VIRTUAL MEETING OF THE BIRMINGHAM PLANNING BOARD
WEDNESDAY, MAY 26, 2021
7:30 PM

SUBJECT: 239 N. Old Woodward – Bloom Bistro – Special Land Use Permit, Final Site Plan & Design Review

SUBJECT: 115 Willits – Mare Mediterranean – Special Land Use Permit, Final Site Plan and Design Review

Sheet Number:

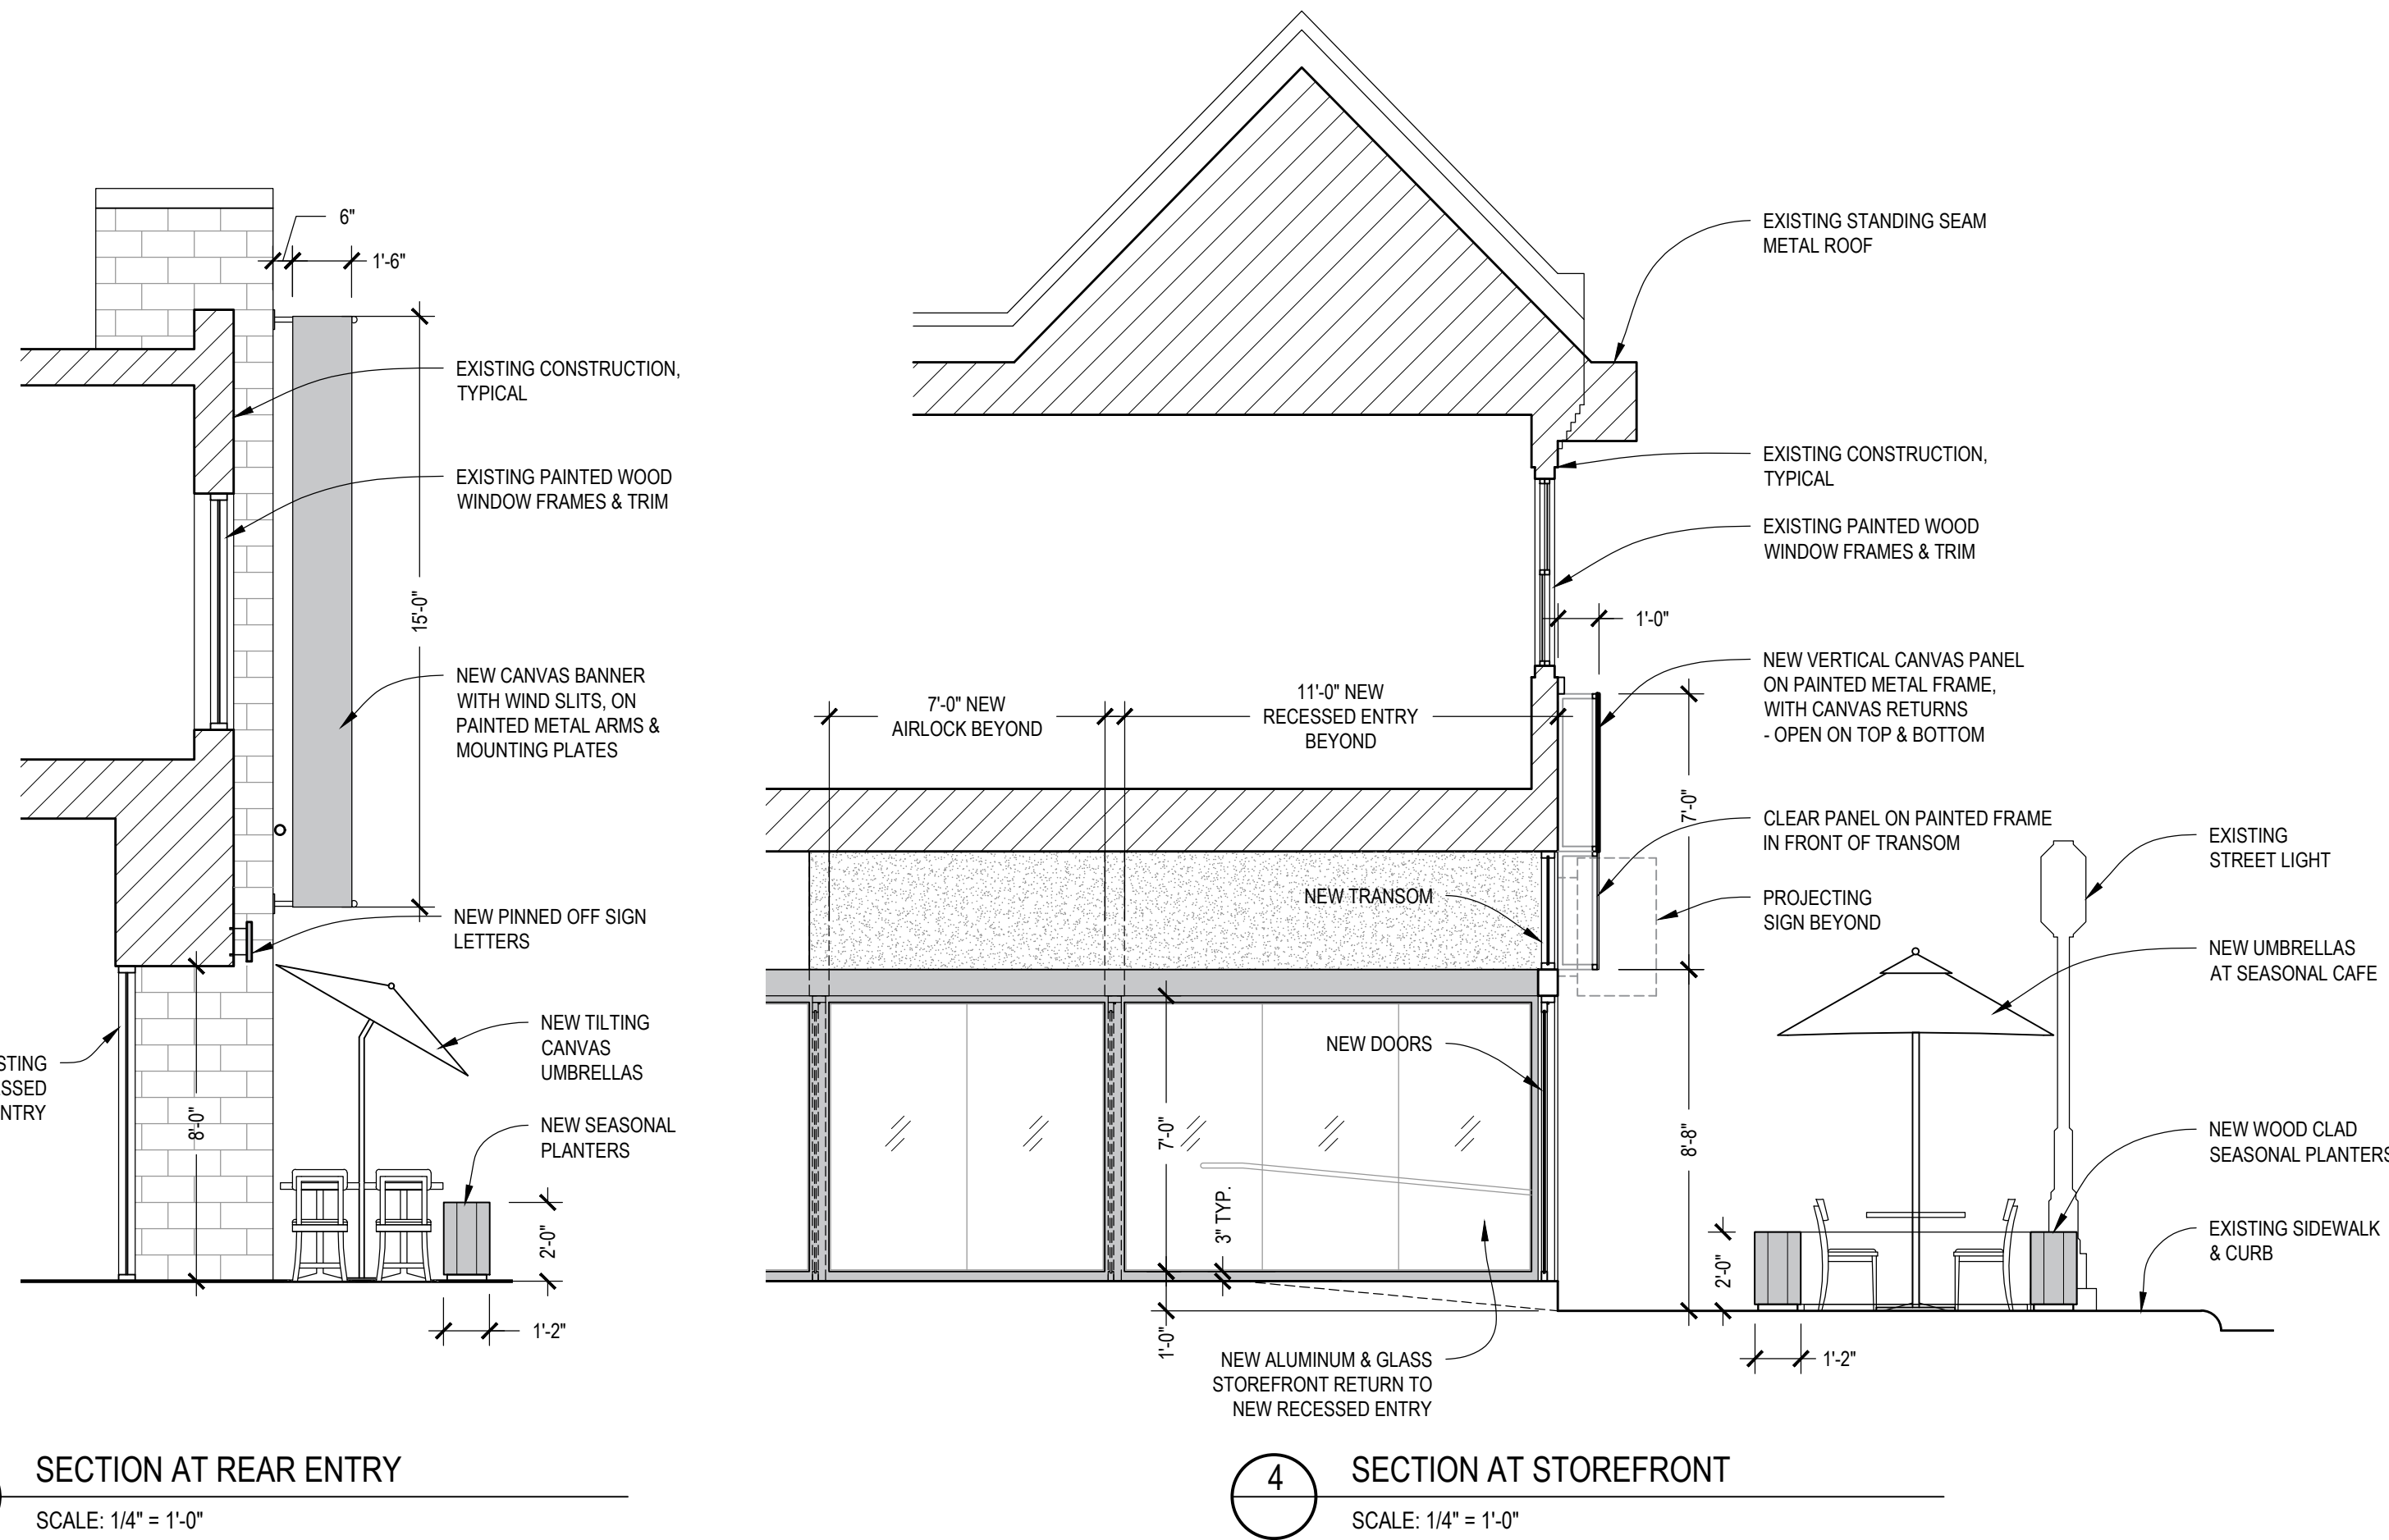
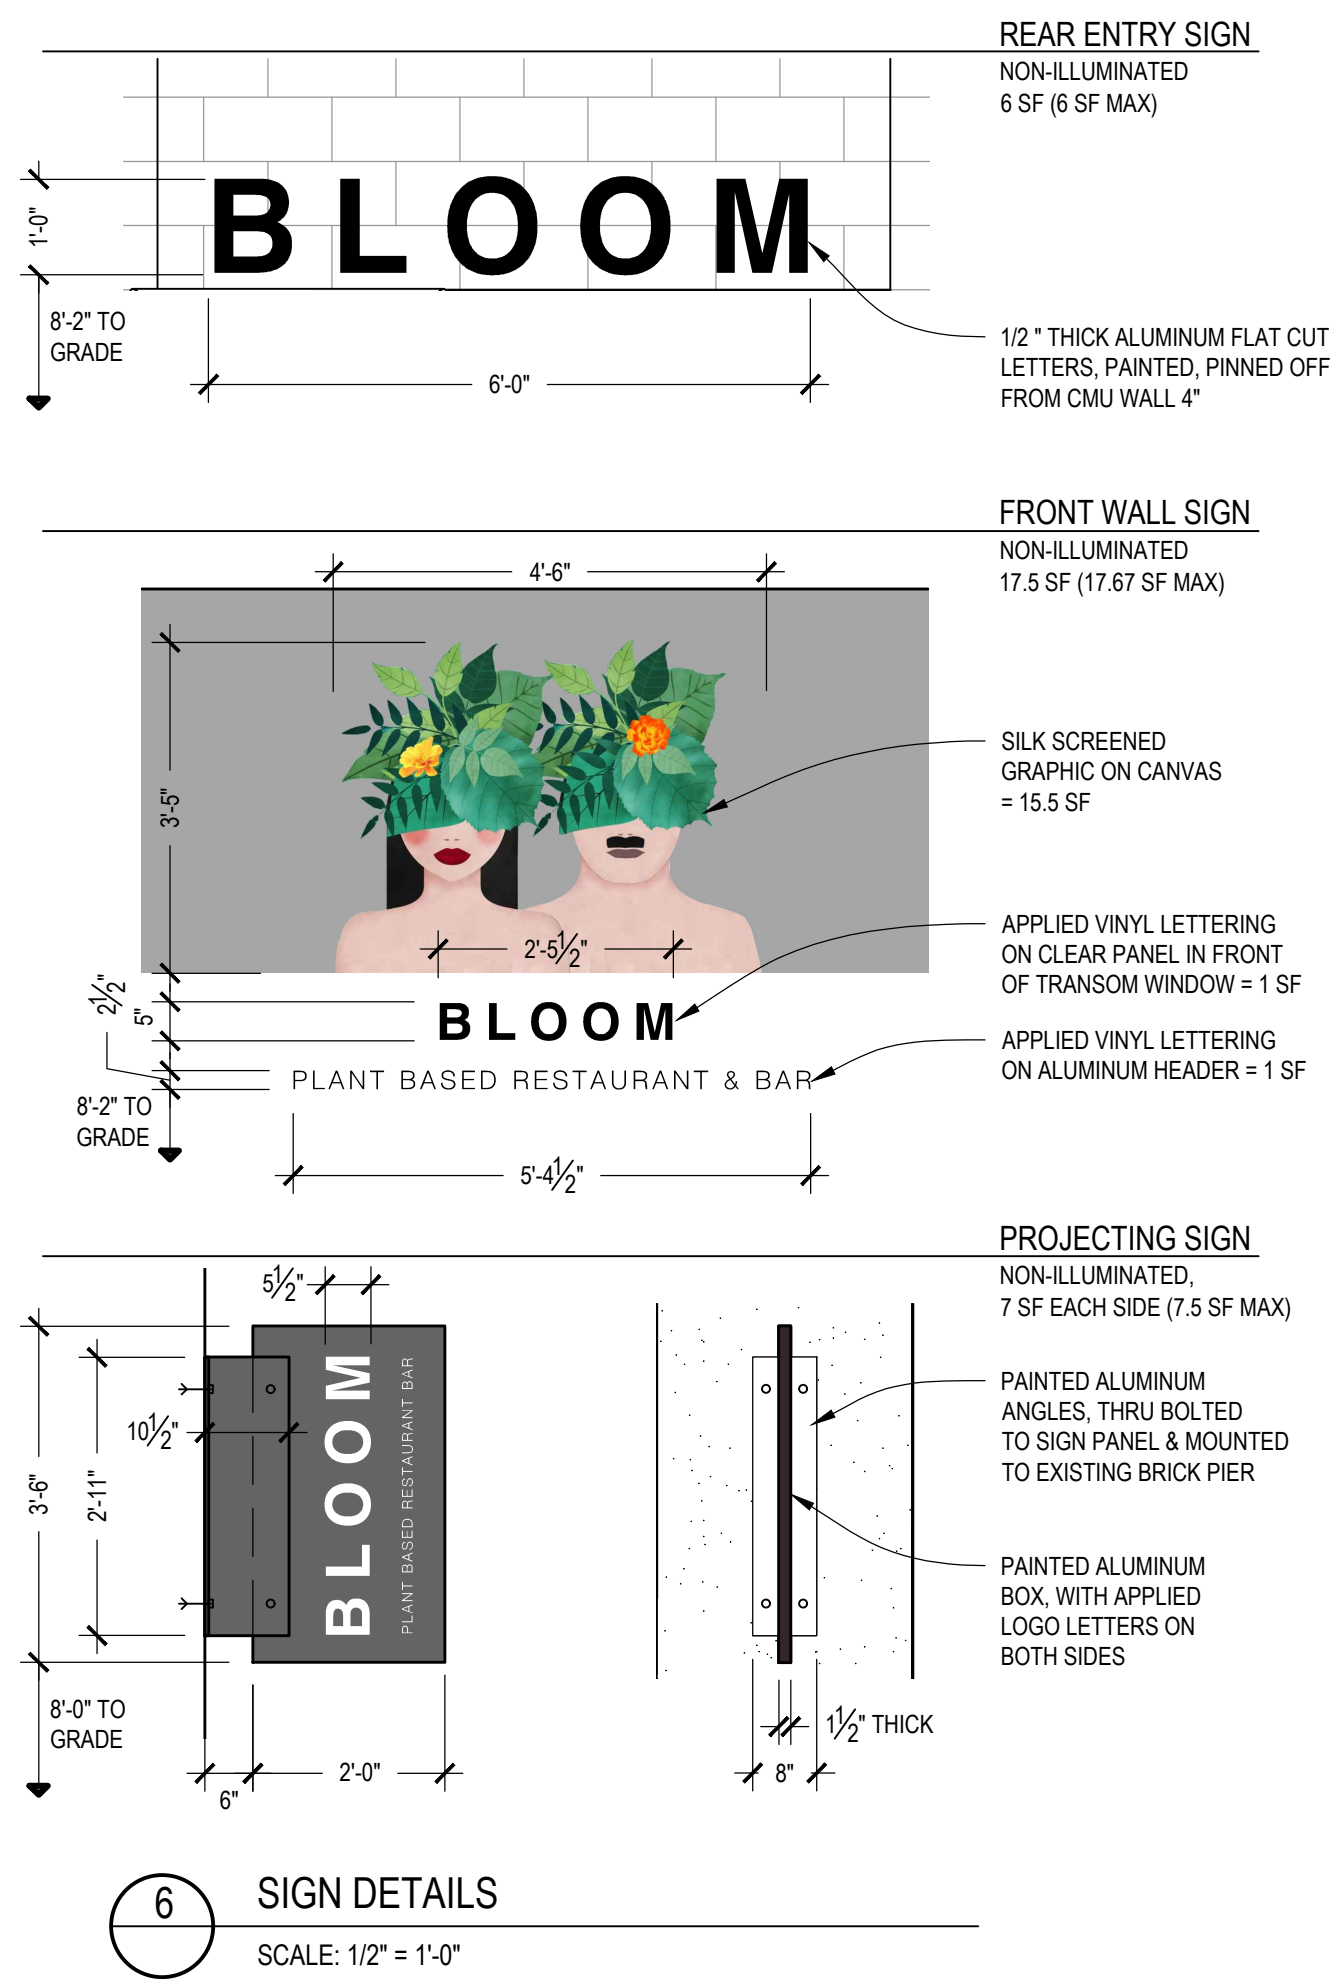
As noted above, the applicant is proposing to rework the entire storefront and add new glazing, which requires them to meet the glazing requirements outlined in Article 3, Section 3.04 of the Zoning Ordinance. The New Storefront Elevation drawing shown on sheet A-2 contains a calculation showing that the new storefront contains 71% glazing in between 1 ft. and 8 ft. from grade. However, the applicant has not submitted specification sheets on any proposed glazing to ensure that the clarity requirements of 80% VLT are met. **The applicant must submit specification sheets with Visual Light Transmittance figures for all proposed glazing.**

In summation, **the applicant must revise the sign concept for Bloom to meet the dimensional requirements of the Sign Ordinance**

2 REAR ALLEY ELEVATION

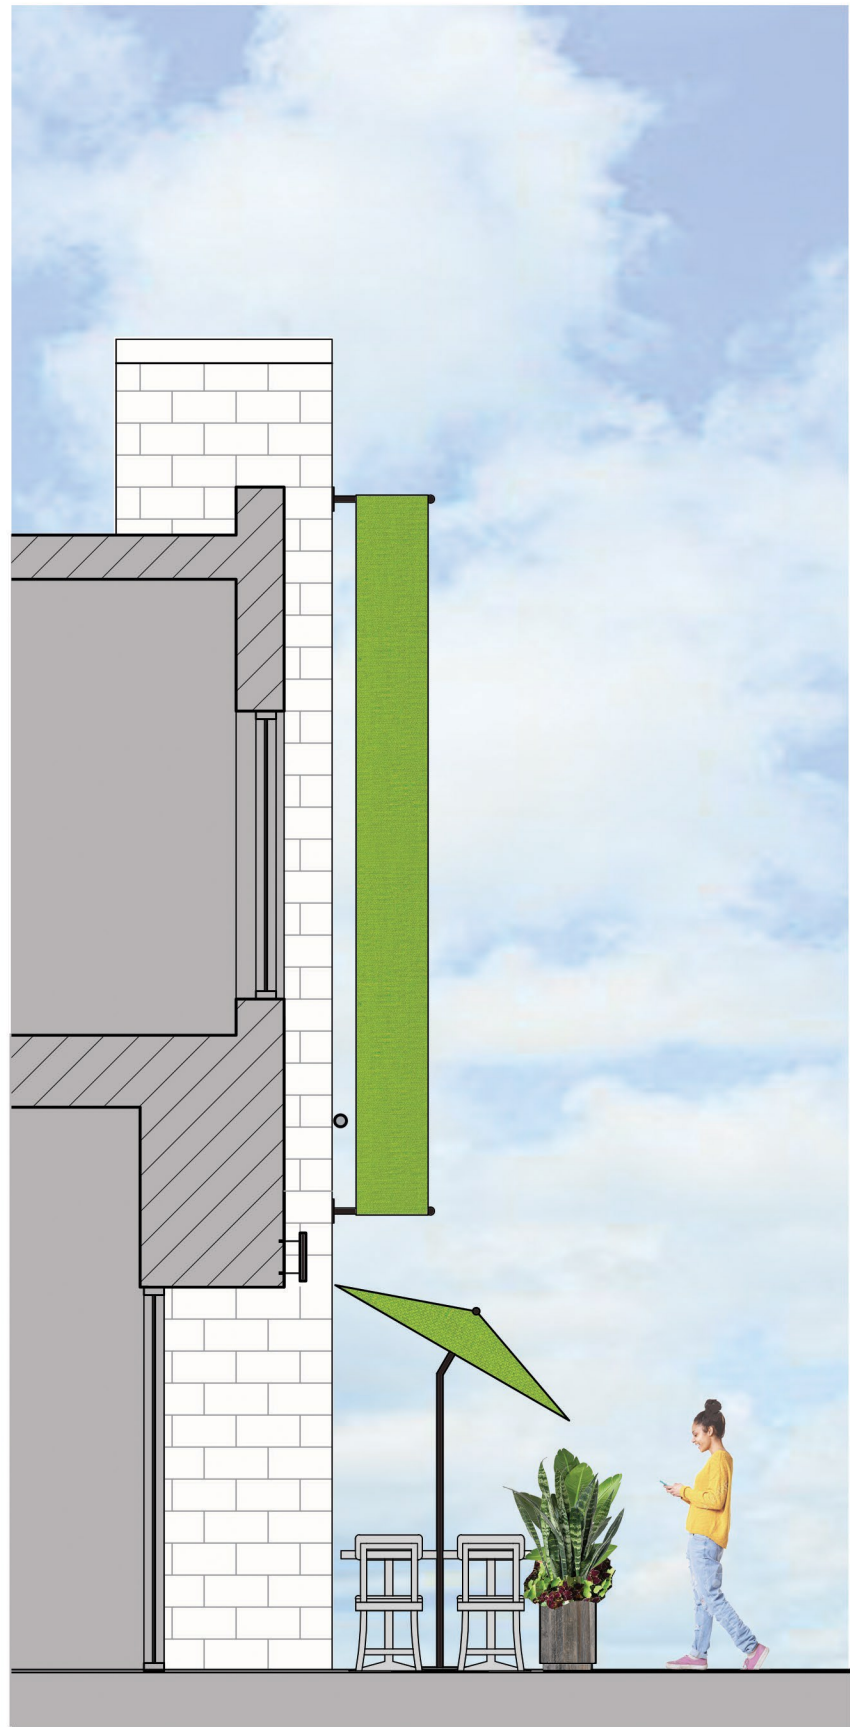
At this time, the rear sign as proposed does not meet the requirements of the Activation Overlay District, as the proposed sign is not a projecting sign mounted perpendicular to the façade. Thus, **the applicant must submit a revised sign plan that meets the requirements of the Activation Overlay District.**

1. The applicant is proposing a plain (no text/graphics), vertical canvas banner that extends from the top of the first floor to just below the roofline at the rear of the building along the alley. Article 4, Section 4.74 (4)(D)(c)(i) states that removable architectural elements may be approved by the Planning Board to project into the right of way provided that they are constructed to support applicable loads without any ground mounted supports on public property. Encroachments with less than 15 ft. of clearance above the sidewalk shall not extend into or occupy more than two-thirds of the width of the sidewalk or 5 ft., whichever is less, and must not interfere with any existing or planned streetscape elements or infrastructure. The proposed banner extends 1.5 ft. into the public right-of-way, meeting the requirements of the Ordinance. Thus, **the applicant must receive**

approval from the Planning Board for the projection into the right-of-way.
